World Forum for Harmonization of Vehicle Regulations

Proposal for Amendment 3 to UN Global Technical Regulation No. 9 (Pedestrian safety)

Submitted by the Working Party on Passive Safety*

Figure 1 (a)
Transfer of real life accident situation with deploying DPPS to ambient conditions for impactor testing.

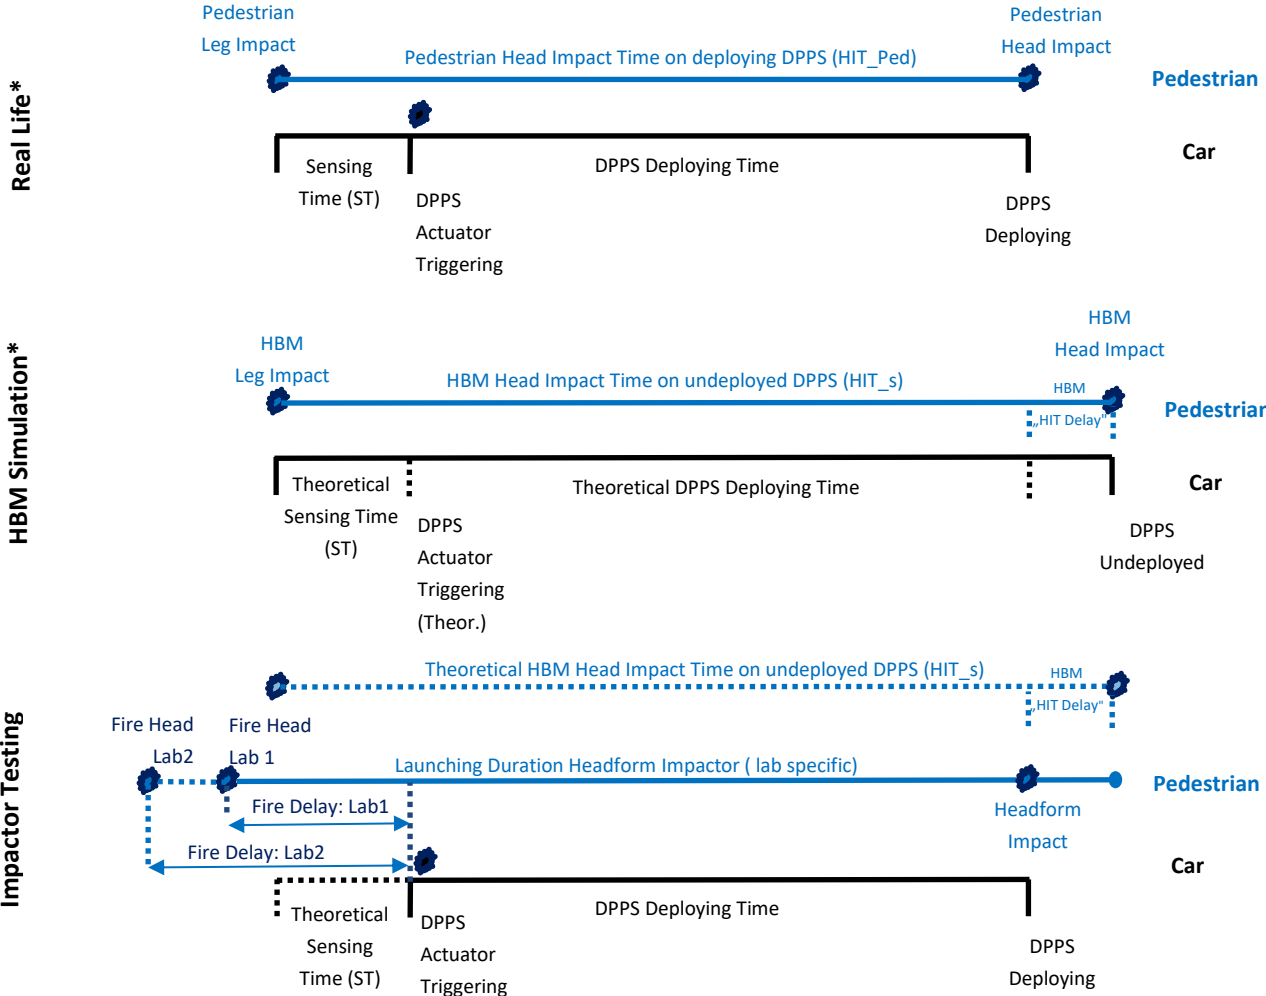
300. For the dynamic test option, the IWG investigated possible misinterpretations of the calculated and actual launching time of the headform impactor during dynamic tests. Since the fire delay between the initiation of the launch of the headform and the triggering of the DPPS actuators is, amongst other things, based on the HIT of the HBM on the undeployed DPPS (HIT_s), but the actual headform impact takes place on the deploying DPPS (see Figure 1 (a)), the actual launching duration will deviate from the calculated one, as depicted in Figure 1 (b).

Figure 1 (b)
Effect of DPPS Deployment on Launching Duration Headform Impactor (Example).

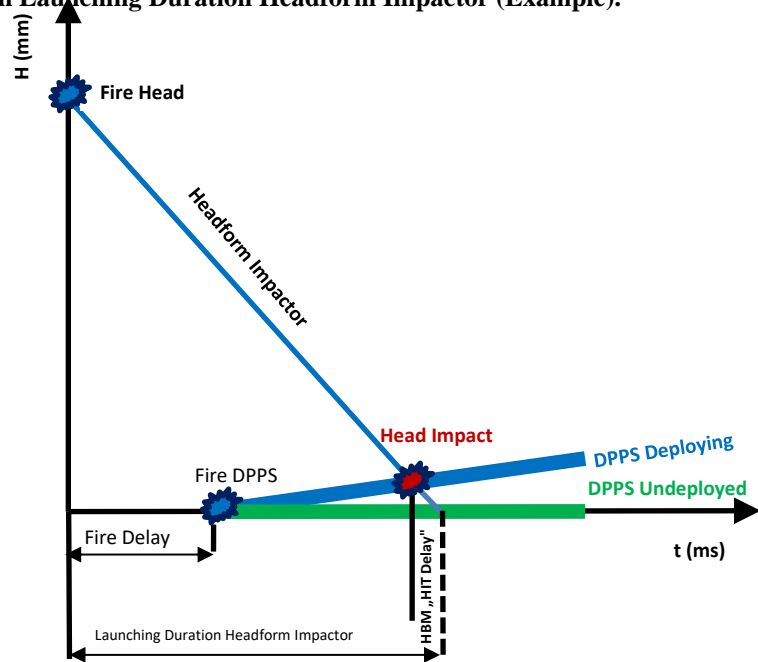
This needs to be taken into account in the course of verification of ambient conditions for dynamic tests.

"Figure 11
Determination of the Detection Test Area (see paragraph 3.19): examples

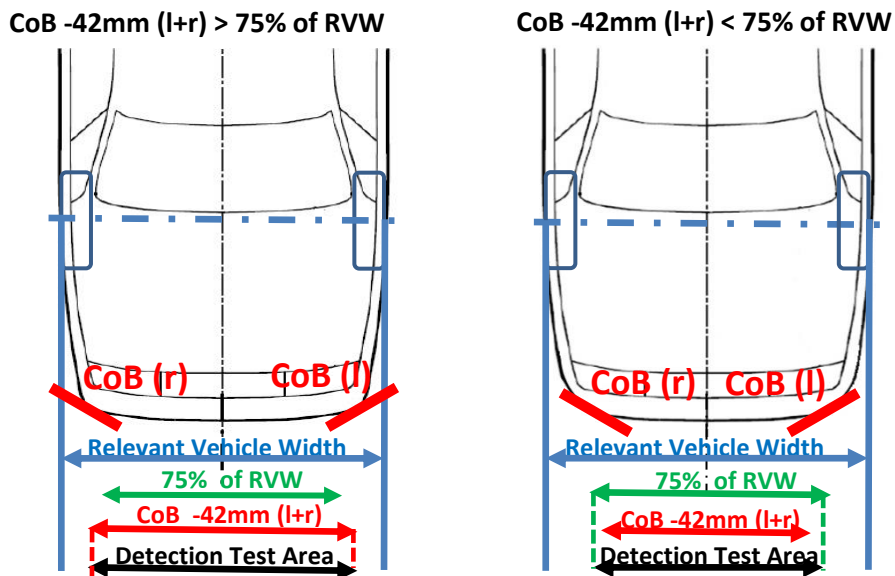
Insert new Figure 11, to read:

Figure 1-1
Deployment Time History Curve

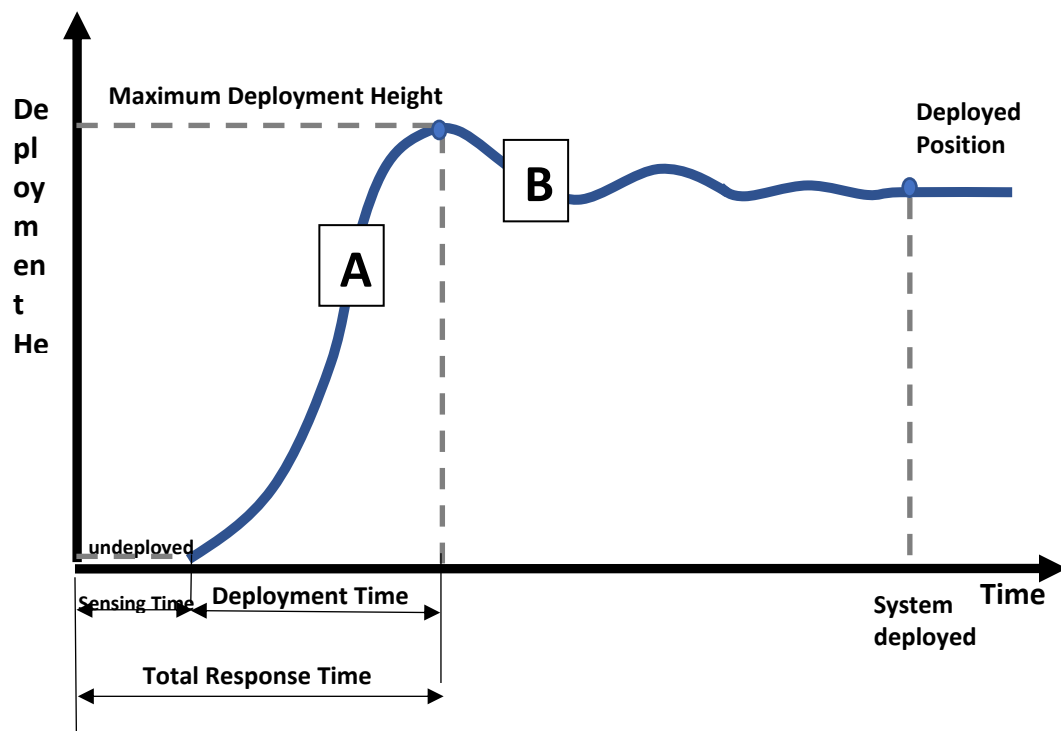
- (a) In case of $HIT_d < TRT$, the headform test shall be performed dynamically;
- (b) In case of $HIT_d \geq TRT$, the headform test may be performed either statically at a height no more than the deployed position or dynamically.

Figure 1-3
Head Impact Time(s for synchronisation) versus Wrap Around Distance (HIT_s vs WAD)

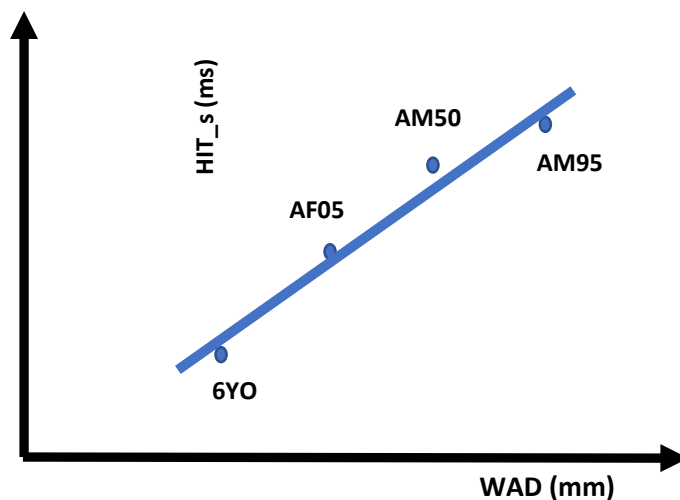
- 4.2.1.2. To enable dynamic testing to be conducted, HIT_s and ST are required inputs, which shall be established by the following:
 - (a) HIT_s (see Fig. 1-3 hereafter, obtained from Annex 2, Figure 2-3).

- 4.2.1.3. Fire Delay
The test facility shall ensure that the head impact occurs at the correct time relative to the deployment of the DPPS, taking into account the HIT_s for the corresponding WAD of the head impact point from Figure 1-3 and ST, as shown in the example in Figure 1-4 (a) below.
"Fire Delay" is the elapsing time between the initiation of the headform launch and the initiation of the DPPS deployment module.
It is determined according to the equation:
Fire Delay = Launching Duration Headform Impactor – (HIT_s – ST).
The "Launching Duration Headform Impactor" is rig-specific and is the time period between launching of the headform impactor and the theoretical time of head impact on the undeployed DPPS. Due to the DPPS deployment during

Figure 1-4 (a)
Synchronization of Test Rig and DPPS Deployment (Example).

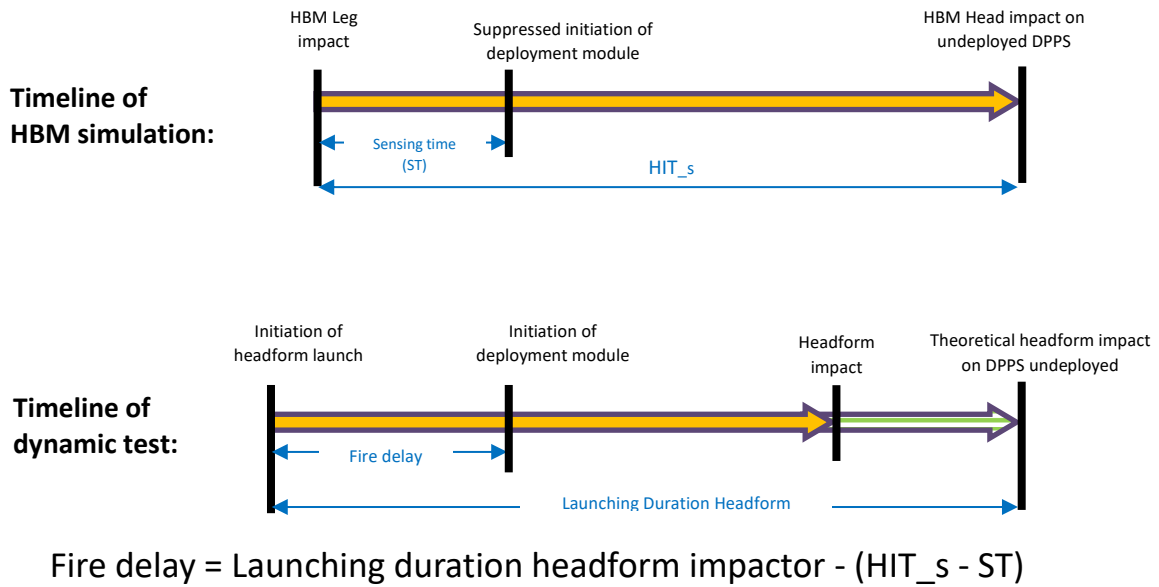
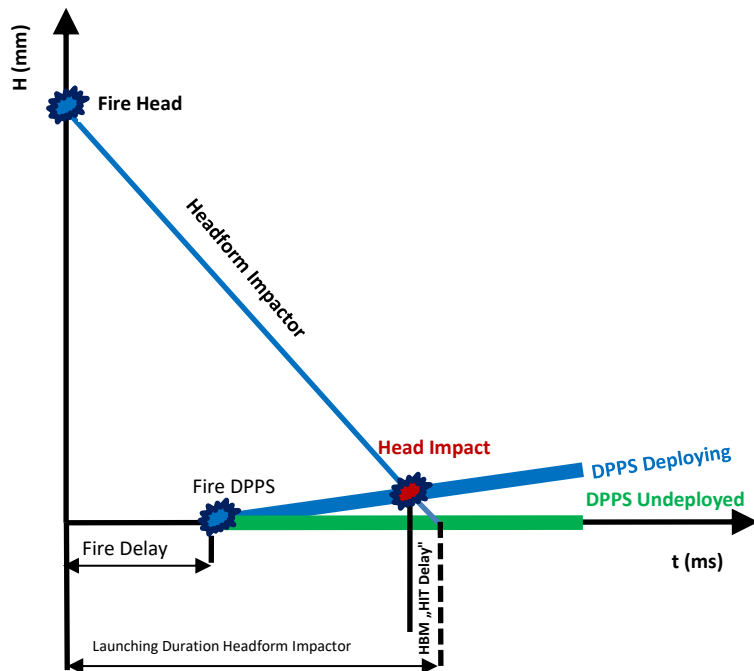
testing, the actual launching duration of the headform impactor is expected to differ from the calculated launching duration headform impactor (time difference: see example in Figure 1-4 (b)).

Figure 1-5
 Scheme of HIT_d vs WAD for Combined Testing

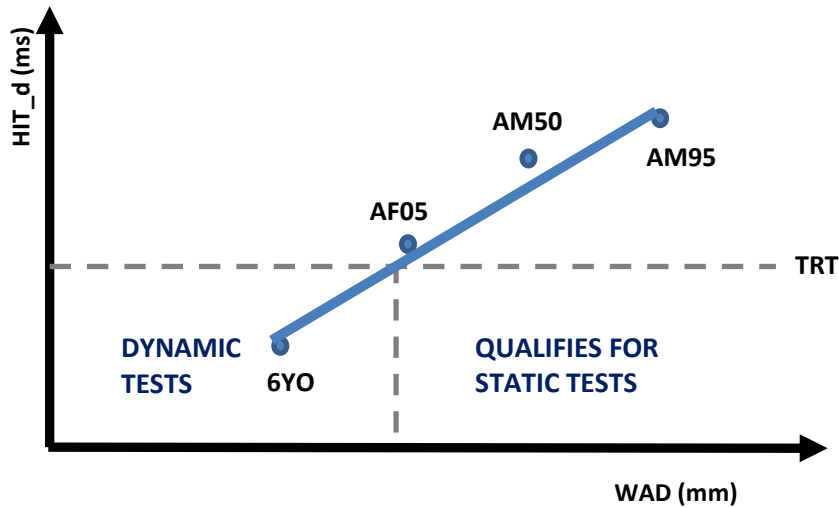
If the headform test area consists of sections where the HIT_d at the corresponding impact point is less than TRT (HIT_d < TRT), as in the A section in Figure 1-1, and sections where the HIT_d at the corresponding impact point is greater than or equal to TRT (HIT_d ≥ TRT), as in the B section in Figure 1-1, then all test points forward of the corresponding WAD (HIT_d < TRT) shall be tested dynamically. The remaining section of the headform test area may be tested statically (see Figure 1-5 below, obtained from Annex 2, Figure 2-2).

Figure 2-1

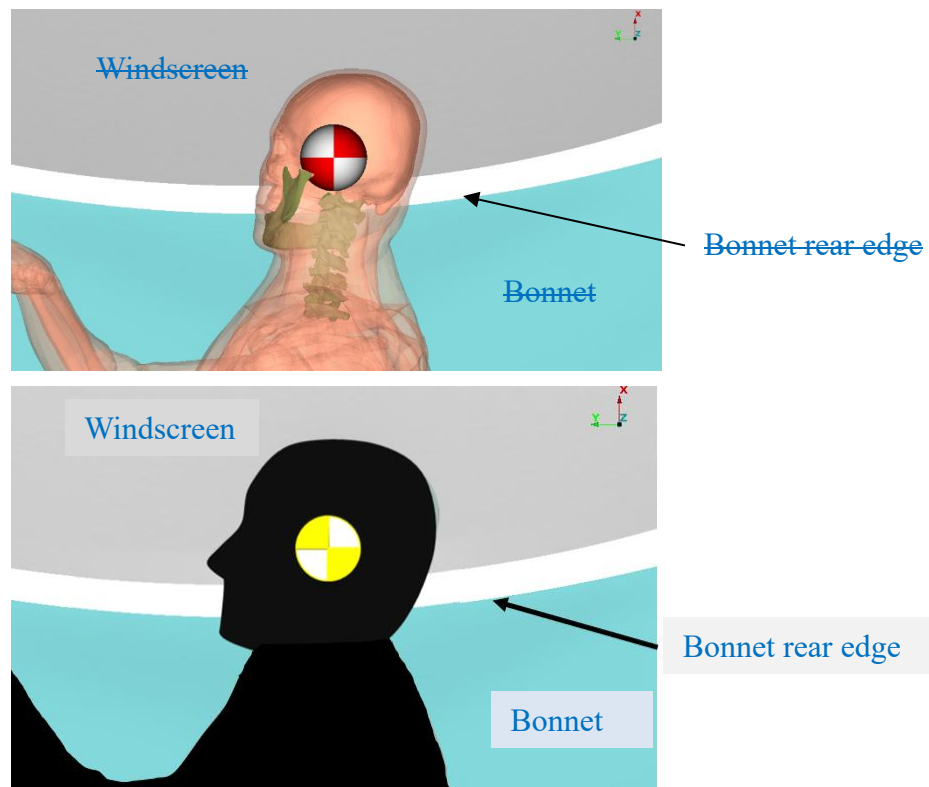
If only one HBM hits the DPPS properly, the next tallest HBM shall also belong to the selected HBMs.

Example (where the CoG of the head lies behind the DPPS at time of contact. This HBM does not hit the DPPS properly (only contact with chin of HBM))

Figure 2-2
Wrap Around Distance versus Head Impact Time_for decision
(WAD vs HIT_d)

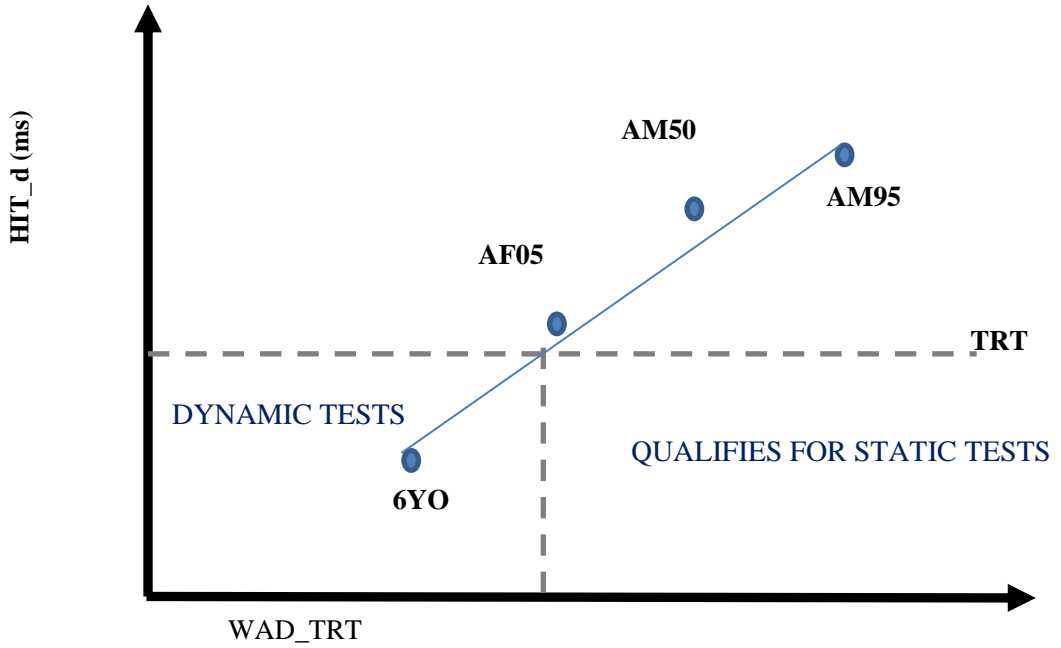
Based on the results of Table 2-3, a graph shall be plotted using a linear regression line for comparison with TRT in the diagram as shown in Figure 2-2.
